The current outline planning application 15/01012/OUT is for 'Access' and 'Layout' for two large industrial style employment sheds for mixed employment use on a greenfield to the SE of RAF Bicester, see Figure 1. This is the first phase of a proposal to site four large sheds on the 18.45 hectare site, see Figure 2.

SECTION C: ASSESSMENT OF THE IMPACT OF THE OUTLINE PLANNING APPLICATION 15/01012/OUT

Fig 27 Design and Access Statement - Landscape Parameters Sections (1)

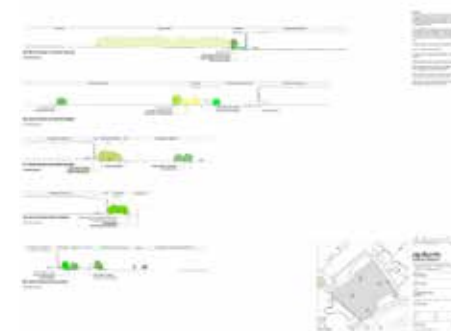
C.6.1 The proposed 10m offset to the bomb stores needs to be further explored through wire-frame views and site sections to determine what height and layout of development is likely to be permissible.

Fig 30 Design and Access Statement - Access & Circulation

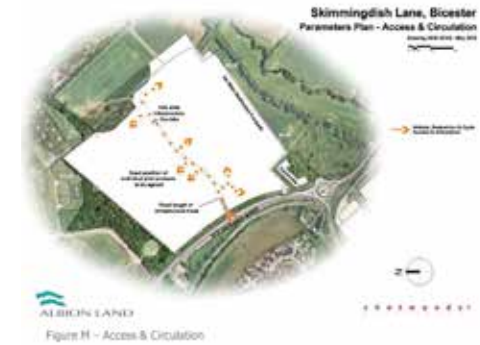
The footpath also needs to be identified on the circulation plan, compete with proposals for public art and interpretation of the adjacent RAF Bicester site.

Fig 34 LVIA View 3 shows the Watch Tower with the application site beyond

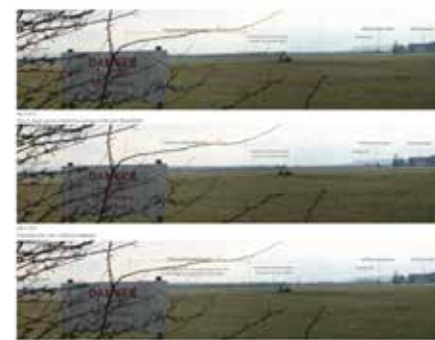
Although views 3 and 4 show the Watch Office and Tower in context with the hedgerow/tree boundary, the horizon, Graven Hill, the built distribution sheds, and the existing hangers, there are no views from the Watch Office and Tower, a building specifically designed for watching over the airfield, the skies and horizon. See Figures 14-17.

Landscape viewpoints - views 3 and 4 look from Buckingham Road to the application site and show the Watch Office with Tower and the Type C hangers. The key views highlighted in the RAF Bicester Conservation Area Appraisal are from the Watch Office with Tower; the ground floor windows are tall with a relatively high cill allowing views across and skyward across the whole airfield including views beyond to the countryside; the Observation Tower at first floor allows a 360 degree view, as do the roof tops.

A baseline view from the Grade II listed Watch Office and from the observation Tower above towards the development site needs to be taken showing the existing view, the wartime view prior to the hedgerows and trees becoming overgrown and the proposed view of the two and four sheds. The landscape mitigation measures can then be added. A similar exercise could be done for the scheduled Seagull Trenches and pillboxes.

Fig 37 LVIA the proposed buildings in grey to Skimmingdish Lane adjacent to the care home

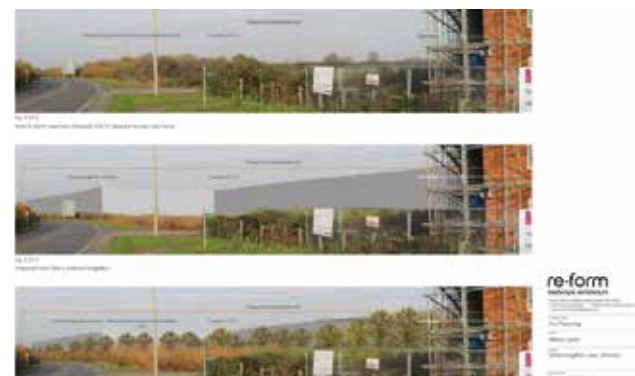
D.3.1.4 Views from Skimmingdish Lane were submitted with greyed-areas depicting the proposed sheds within the B11 site. It would be useful to show the proposed buildings shown in the masterplan at the gateway to the site, from the Care Home and within the site to ensure a sense of place.
